NRC Staff Responses to Public Comments on
Draft Regulatory Guide DG-1146
“A Performance-Based Approach to Define the Site-Specific
Earthquake Ground Motion”

This document contains NRC staff responses to comments received during the public comment period for Draft Regulatory Guide DG-1146, which ended on December 15, 2006. During this period, the NRC received the following sets of comments (in chronological order):

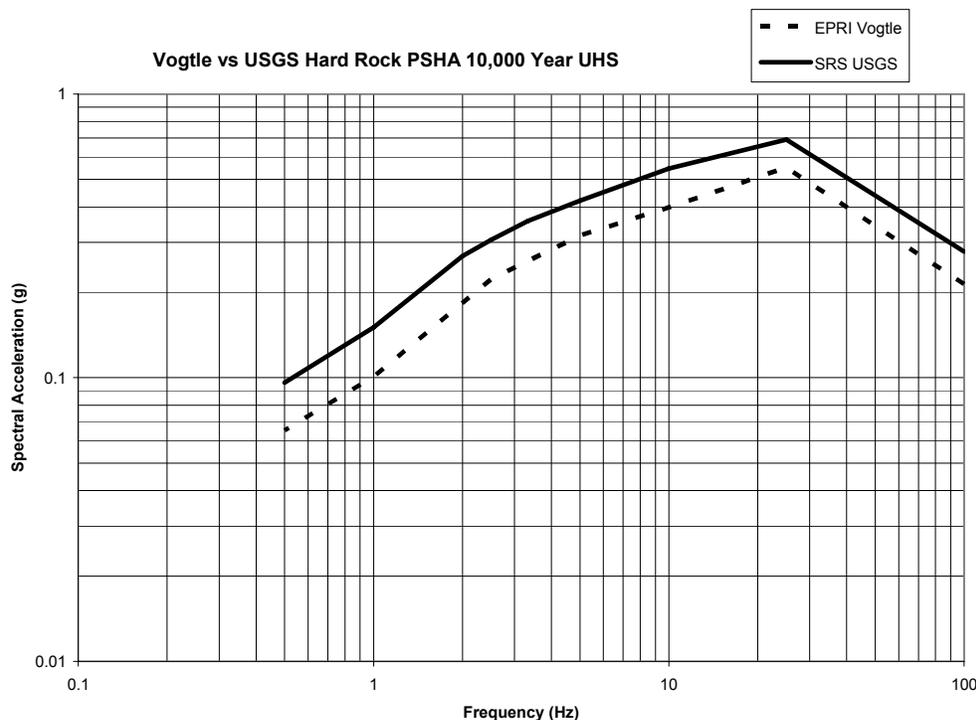
Jeffrey K. Kimball Comment 6 (December 13, 2006)

To compound these issues, the recent submission of the Vogtle ESP application, Site Safety Analysis Report, further demonstrates that PSHA stability does not exist. Consistent with other ESP applications (North Anna, Grand Gulf, Clinton), the Vogtle applicant has chosen to use an update to the EPRI PSHA to assess seismic hazard and establish appropriate ground motion for seismic design. The update to the EPRI PSHA for Vogtle, however, is significantly different than the EPRI PSHA work used by the preceding three ESP applicants, and inconsistent with material provided by EPRI as part of the ongoing dialog regarding resolution of seismic hazard issues (Program on Technology Innovation: Assessment of a Performance-Based Approach for Determining Seismic Ground Motions for New Plant Sites, V1 Performance-Based Seismic Design Spectra, V2 Seismic Hazard Result at 28 Sites; EPRI Technical Reports (1012044 and 1012045). Specific issues related to the EPRI PSHA update used for Vogtle are provided following the remaining comments.
